SUBJECT: ISSUANCE OF AMENDMENT NO. 124 TO FACILITY OPERATING LICENSE  
NO. DPR-71 - BRUNSWICK STEAM ELECTRIC PLANT, UNIT 1, REGARDING  
CYCLE 7 RELOAD (TAC NO. 69200)

AMENDMENT NO. 124 TO FACILITY OPERATING LICENSE NO. DPR-71 - BRUNSWICK, UNIT 1

Amendment No. 124  
License No. DPR-71

ATTACHMENT TO LICENSE AMENDMENT NO. 124

Figure 3.2.1-1

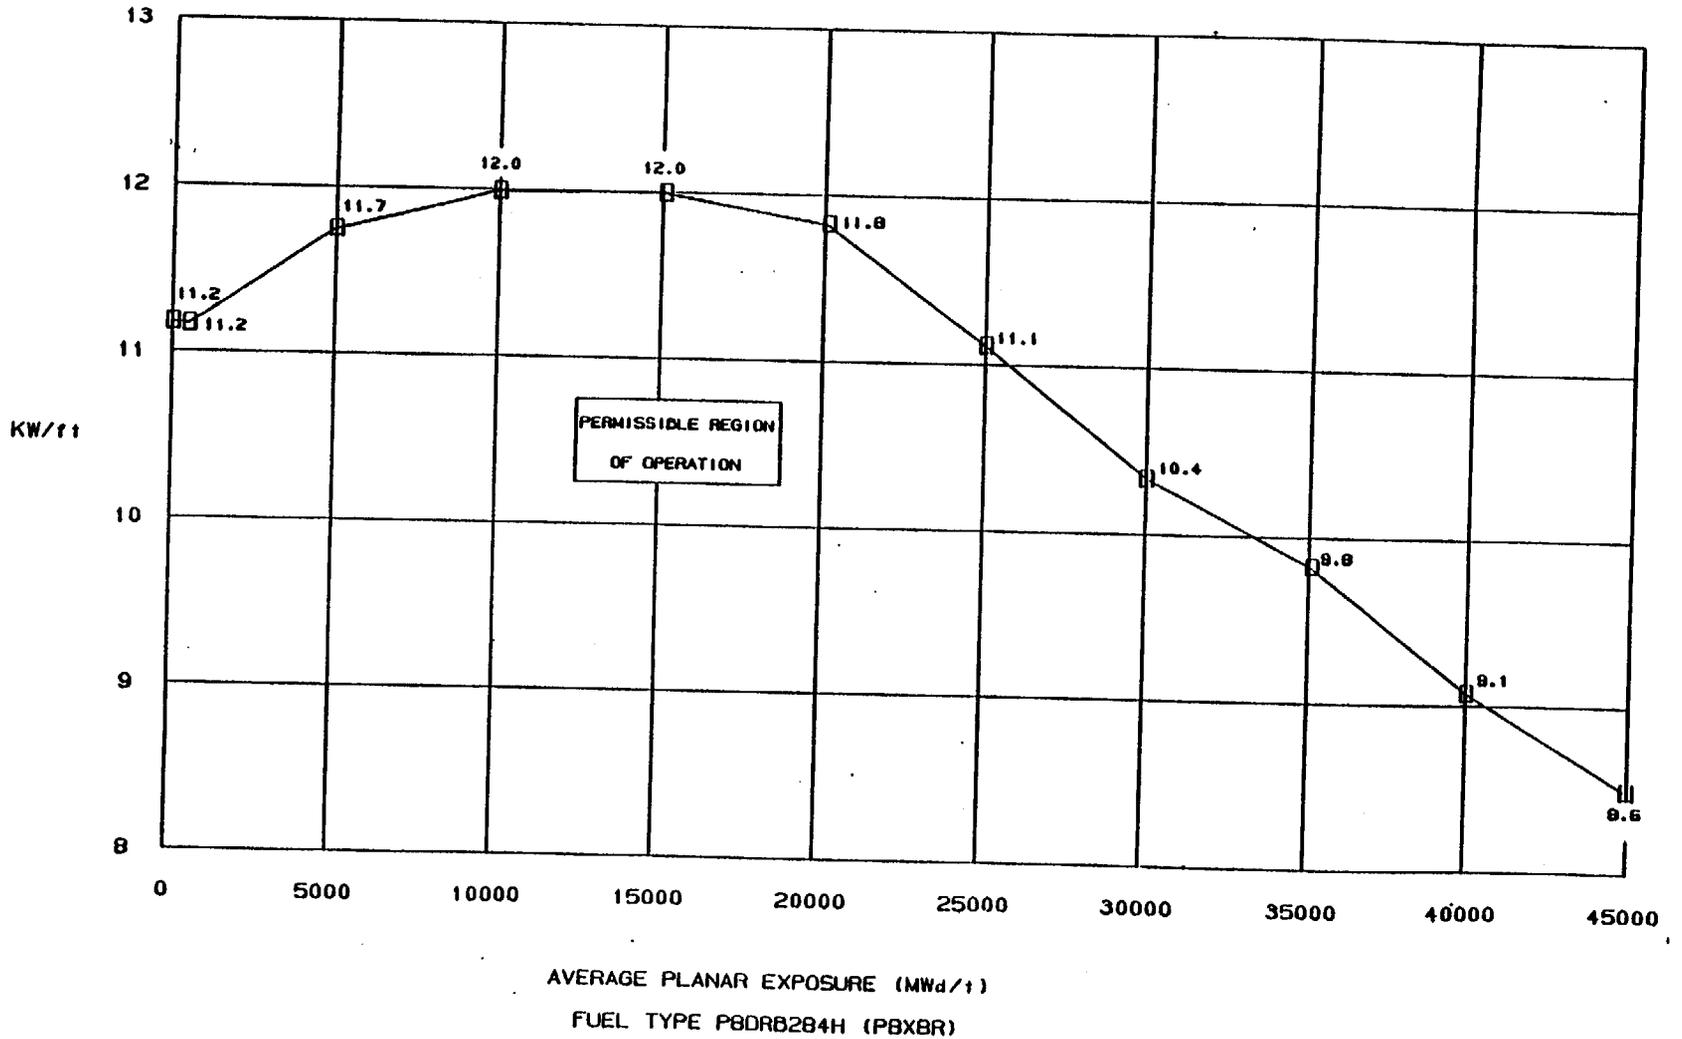
The calculational procedure used to establish the APLHGR shown on Figures 3.2.1-1, 3.2.1-2, 3.2.1-3, 3.2.1-4, and 3.2.1-5 is based on a loss-of-coolant accident analysis. The analysis was performed using General Electric (GE) calculational models which are consistent with the requirements of Appendix K to 10 CFR 50. A complete discussion of each code employed in the analysis is presented in Reference 1. Differences in this analysis compared to previous analyses performed with Reference 1 are: (1) The analysis assumes a fuel assembly planar power consistent with 102% of the MAPLHGR shown in Figures 3.2.1-1, 3.2.1-2, 3.2.1-3, 3.2.1-4, and 3.2.1-5, (2) Fission product decay is computed assuming an energy release rate of 200 MEV/Fission; (3) Pool boiling is assumed after nucleate boiling is lost during the flow stagnation period; (4) The effects of core spray entrainment and countercurrent flow limitation as described in Reference 2, are included in the reflooding calculations.

- (a) The Minimum Critical Power Ratio (MCPR) safety limit has been revised to 1.04. This is incorporated in TS 3.1.4.3.a.3 and 3.3.4.b.3. We find this is acceptable.
- (b) MAPLHGR limits are provided for the new fuel. The changes are to TS 3/4.2.1, Figure 3.2.1-4 and Figure 3.2.1-5 and are acceptable.
- (c) The revision of the  $K_f$  curve, Figure 3.2.3-1, is acceptable.
- (d) A 14.4 kw/ft LHGR limit for GE8 fuel has been implemented. The changes are to TS 3.2.4 and are acceptable.

Figure 3.2.1-5

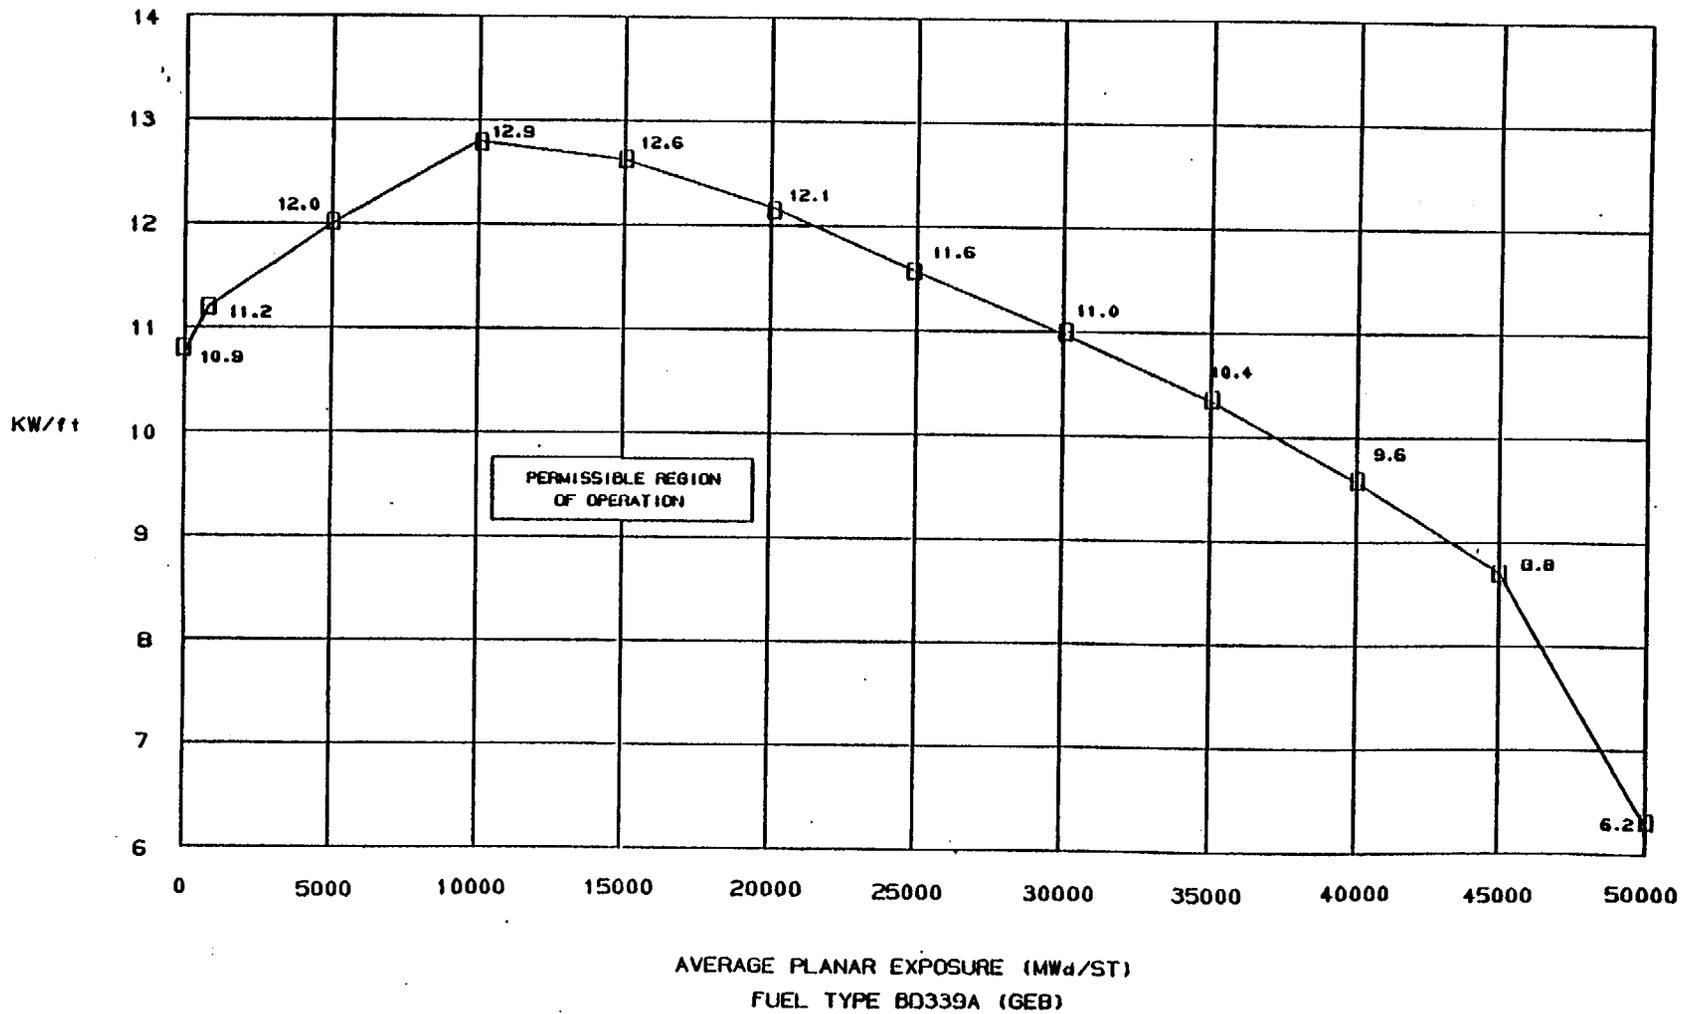
LOCA analyses, using approved methodologies (SAFE/REFLOOD/CHASTE), were performed to provide MAPLHGR values for the new reload fuel assemblies (GE8x8EB). The results are within the limits of 10 CFR 50.46 and are, therefore, acceptable.

TABLE 3.2.3.2-1

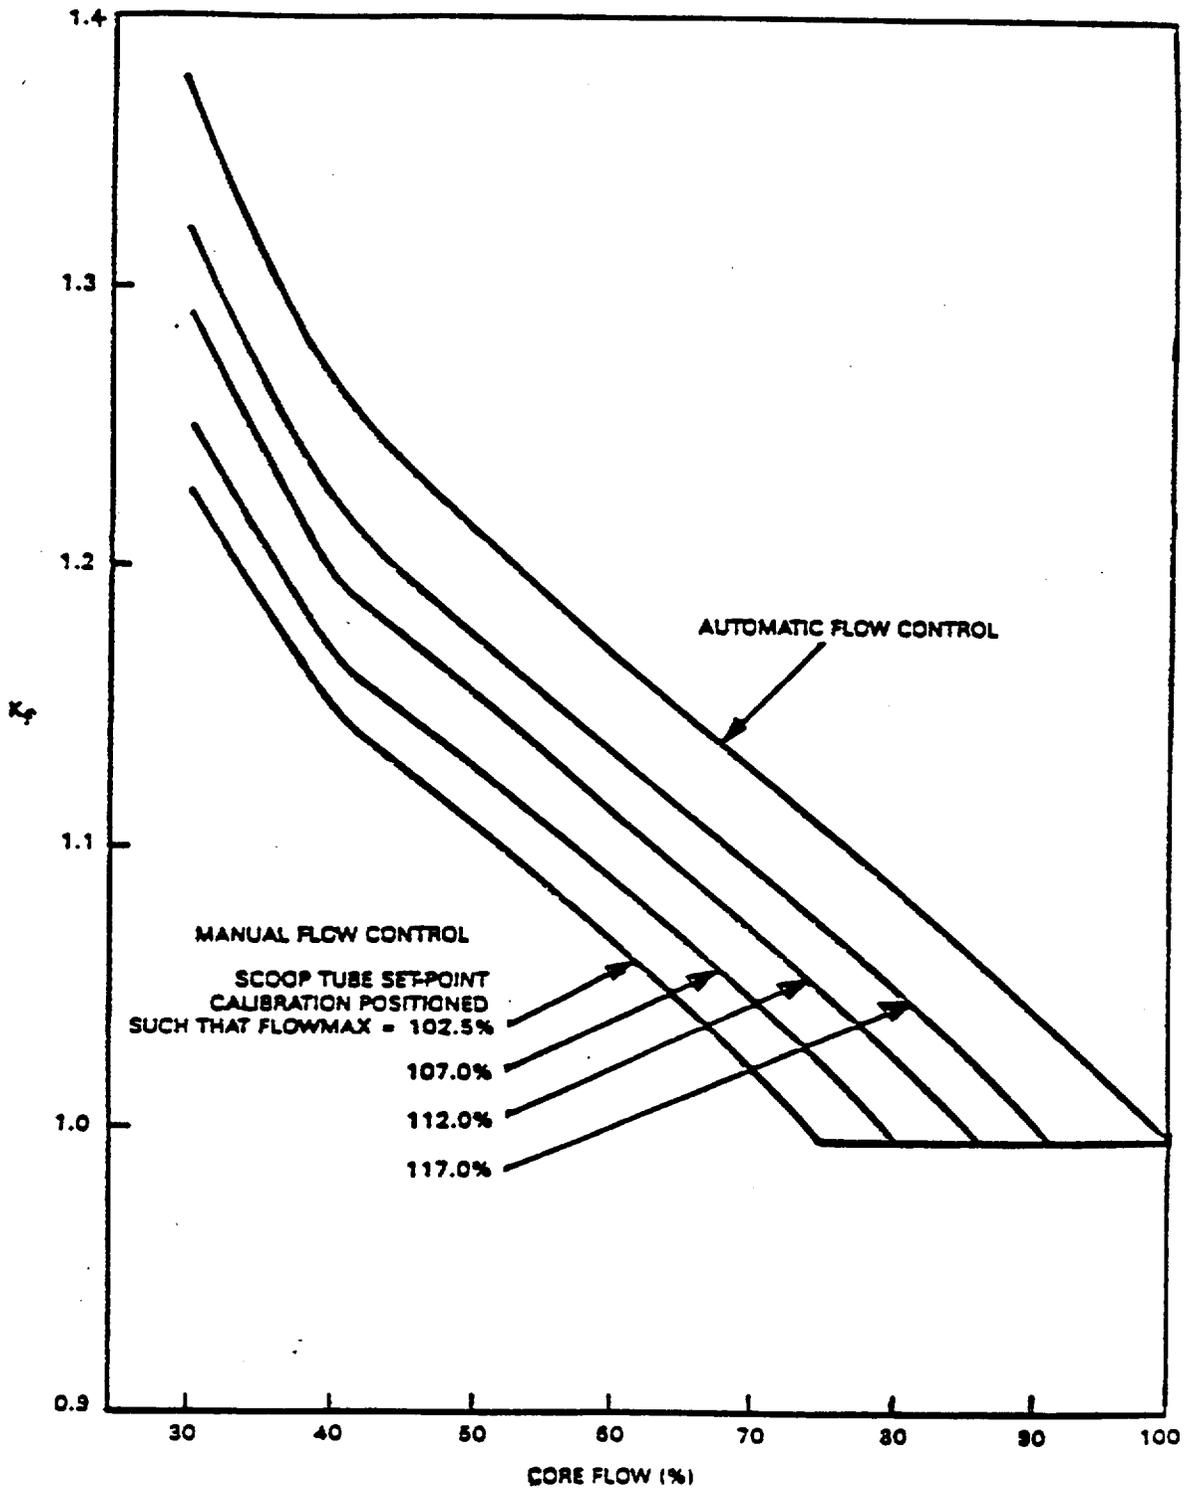
The Operating Limit MCPR (OLMCPR) values are determined by the limiting transients, which are usually Rod Withdrawal Error (RWE), Feedwater Controller Failure (FWCF), Loss of Feedwater Heating (LFH), and Load Rejection Without Bypass (LRWBP). The analyses of these events, using the OLYN option A and B approaches for pressurization transients, provide new Cycle 7 Technical Specification values of OLMCPR in the standard operating region.

The RWE was analyzed on a plant and cycle specific basis (as opposed to the statistical approach) and a rod block setpoint of 107 was selected to provide an OLMCPR of 1.18 for all fuel types. The fuel misorientation event was analyzed with standard methods for the D lattice fuel, giving a nonlimiting MCPR of 1.25.
